Service information SI_2015_105_0073 T3

System type: Precision system T3	Serial numbers: 2055-2067	Date issued: 2015-12-16
ServiceInfo number: SI_2015_105_0073 T3	Issued by: Jonas Petersson	Approved by: Elisabeth Lundahl
Time for action: URGENT ACTION	Report back to Arcoma: Yes	Ref nr: (ÅBO, Complaint) 15-0552
Subject: Spring channel nuts

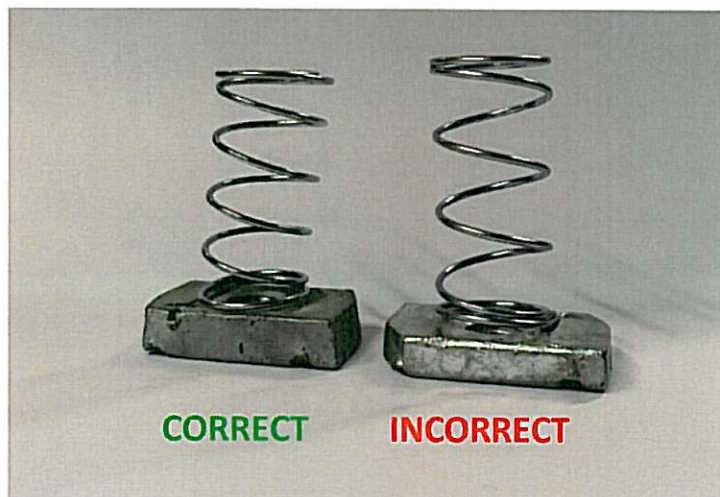
See picture below: CORRECT: nut T=8mm. INCORRECT: nut T=6mm.

Load tests have been performed and the incorrect nut holds the specified load multiplied with four and is considered safe to use. However, it is possible to damage the nut using the tightening torque specified for the correct nut, and for this reason Arcoma advises not to use the incorrect nut on new installations. Replacement nuts will be supplied immediately upon request.

Arcoma has performed an investigation and the conclusion from the mechanical calculations is that the thinner nut is safe to use as long as it is mounted with an appropriate tightening torque. Our suggestion is still to use the correct 8mm version and order replacement nuts from Arcoma Service if needed.

If you have already installed the 6mm version of the nut please contact Arcoma service for advice.
